**IN THE MATTER** of **Private Plan Change 85** – 48 Esmonde Road,  
Takapuna to the Auckland Unitary Plan

**HEARING DIRECTION #3 FROM THE HEARING PANEL**

# Technical Memo

To: **Vanessa Wilkinson**, Planning Consultant  
 cc: **Natasha Carpenter**, Coastal Management Practice Lead, Resilient Land & Coasts  
 From: **Matt Rivers**, Senior Coastal Specialist, Resilient Land & Coasts  
 Subject: **Private Plan Change PC85: 48 Esmonde Road, Takapuna Coastal Hazards Review**

Figure 2: Proposed Zoning for 48 Esmonde Road

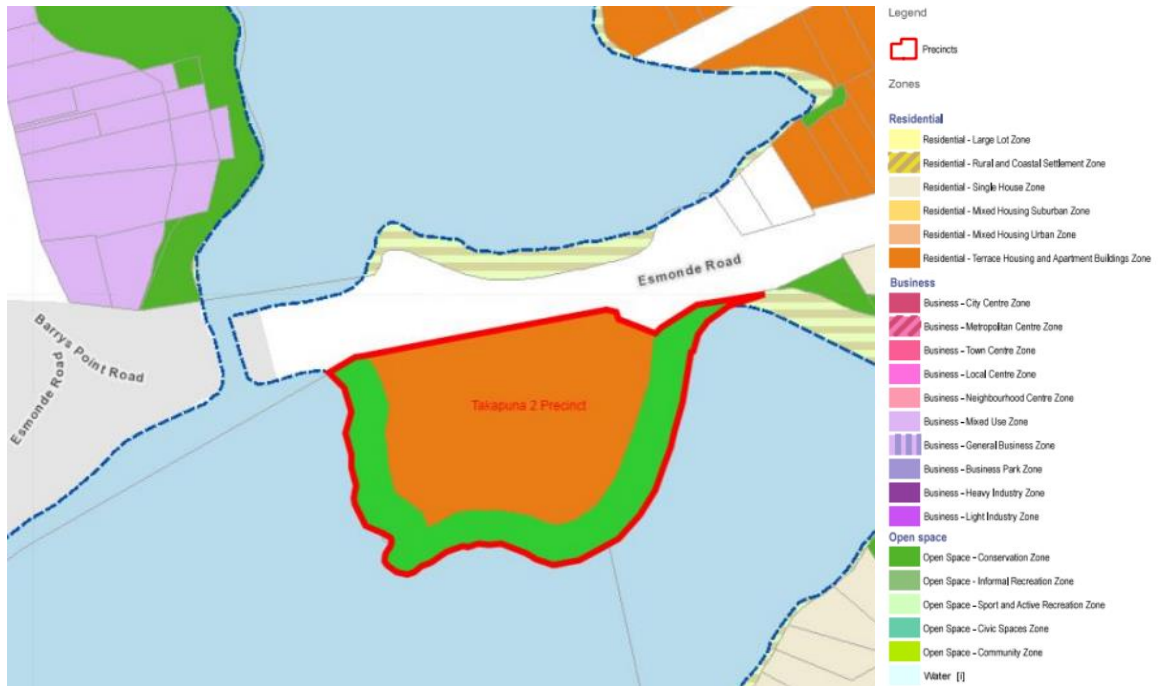
- 2.5 The mapped coastal inundation extent is within the proposed 20m open space zone on the western, southern and eastern sides. Considering the maintenance and enhancement of public access to and along the coast as a matter of national importance, it would be prudent to increase the width of the public easement to the north to allow space for future inundation from extreme weather events and future sea-level rise.

- 5.2 My recommendations in order to make informed decisions regarding the plan change and open space widths is to undertake:
- 5.2.1 A topographic survey of the MHWS boundary and cliff toe. The topographic survey should also note recent landslip debris, which could result in temporary seaward shifts of MHWS but would be expected to erode relatively rapidly so should be considered appropriately with the ASCIE assessment.
  - 5.2.2 Update the site-specific CHA in line with best available information and latest guidance.
  - 5.2.3 Review the open space zone to encompass the full, revised coastal hazard buffer (informed by the updated CHA) and the space required for a shared path (without overlap between the two).
  - 5.2.4 Provide for a cliff top shared path sufficiently set back from the coastal hazard area

Figure 6: Medium confidence sea level rise scenarios including VLM (Source: Takiwa, NZ Sea Rise)

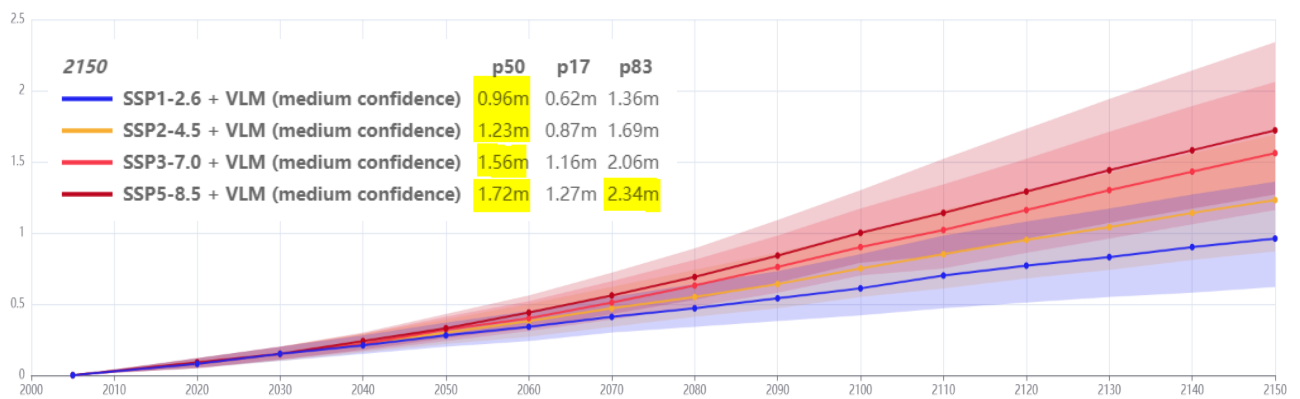
- 2.8 Information on Vertical Land Movement rates across New Zealand has been presented by the NZ SeaRise project and is published through the Takiwa website. Its application is recommended by the MfE Interim Guidance. The nearby Takiwa sites for this area give a vertical land movement of approximately -1.7mm/yr. This gives a relative sea-level rise range of 0.96m – 2.34m by 2150 for the site. This range increases further when checking against the ‘low confidence’ beyond 2150 scenarios.

2.9 To inform future planning and design for the site, the site-specific coastal hazard assessment should be updated to align with the above MfE guidance<sup>4</sup>.

Figure 7: Regional ASCIE lines for 48 Esmonde Road (Source: Auckland Council Geomaps<sup>5</sup>)

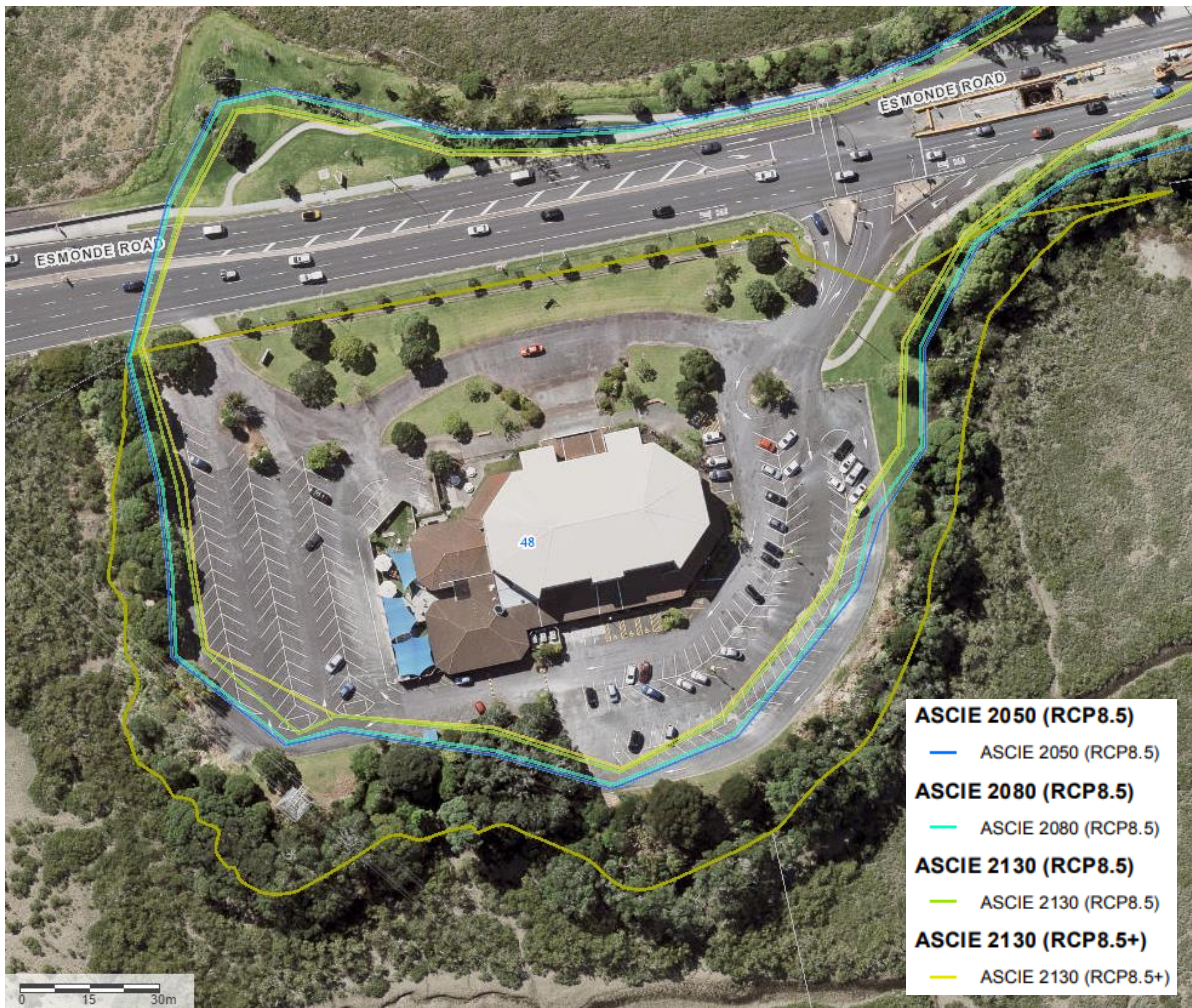
2.12 From my assessment, the ASCIE is the predominant concern from a coastal hazards perspective for the site. Figure 7 shows the regional ASCIE lines for 48 Esmonde Road which shows the ASCIE risk zone as generally around 20m from the MHWS boundary but reaching up to 45m in some areas for this site. The regional ASCIE assessment notes that site-specific assessments are recommended and would supersede the regional assessment provided that more accurate site-specific data is applied and an appropriate methodology is adopted.

Based on the above, there is reason to expect that the ASCIE area has been underestimated in the site-specific CHA and could require a larger coastal hazard buffer.

Figure 8: Schematic illustration of area susceptible to coastal instability and erosion (Source: Coastal Hazard Assessment Guidance, 2022<sup>6</sup>)

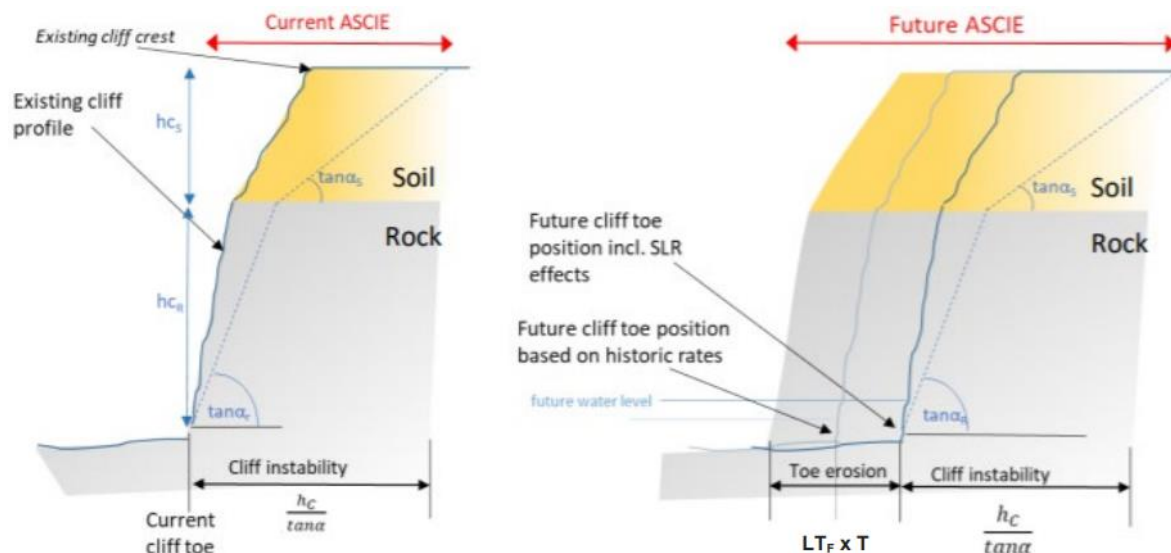
2.13 The site-specific Coastal Hazard Assessment (Tonkin & Taylor) broadly follows the recommended methodology within Auckland Council's Guidance Document 2021/010 ([Coastal Hazard Assessment Guidance 2022 \(aucklanddesignmanual.co.nz\)](https://www.aucklanddesignmanual.co.nz)) illustrated schematically in Figure 8. This site-specific CHA for 48 Esmonde Road's proposed development determines the ASCIE to be between 7.2m and 11.4m from the current cliff toe, increasing to 10.9m to 17.1m when allowing 50% for uncertainty. Based on Appendix P, which suggests that the Mean High Water Mark aligns with the cliff toe, this ASCIE area should be contained within the proposed open space zone. However, a topographic survey is required to accurately establish the MHWS boundary, and the cliff toe.

Figure 11: Tsunami Evacuation Zones (Source: Auckland Council Geomaps)

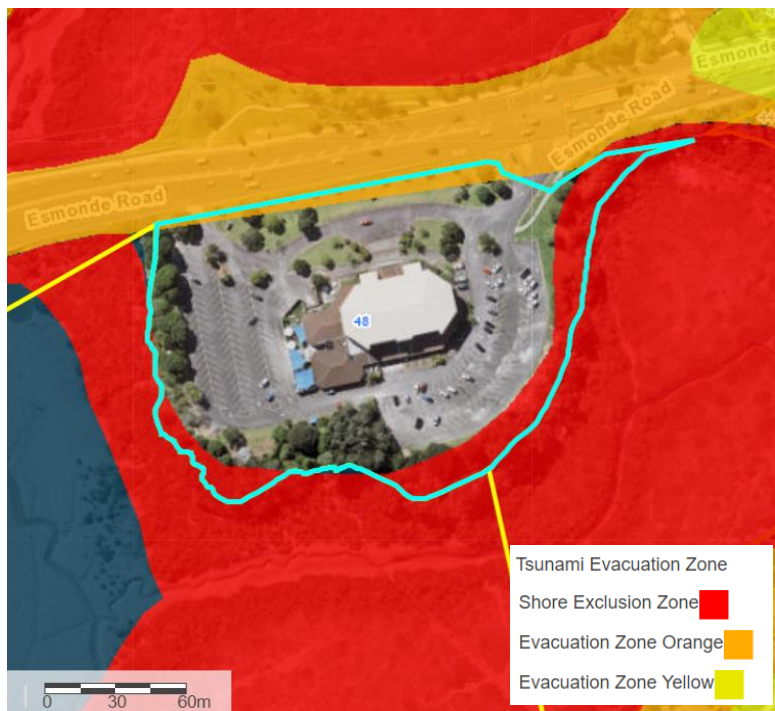
2.15 The majority of the site is safely above the Tsunami evacuation areas for all scenarios (Figure 11). The at-risk areas are around the perimeter and contained within the proposed Open Space – Conservation area. Access along Esmonde Road would be at risk during medium-large scale tsunamis and residents should be made aware of the tsunami risk to the low-lying perimeter but the proposed buildings within the development would be outside of the tsunami risk zone. Tsunamis, as a high magnitude but low frequency hazard are not directly managed through the AUP but predominantly through emergency management provisions. Therefore tsunami risk is not considered to be an obstacle for the proposed plan change. Additionally tsunami risk will be further mitigated through mitigation of the coastal flooding and coastal erosion risks set out previously.
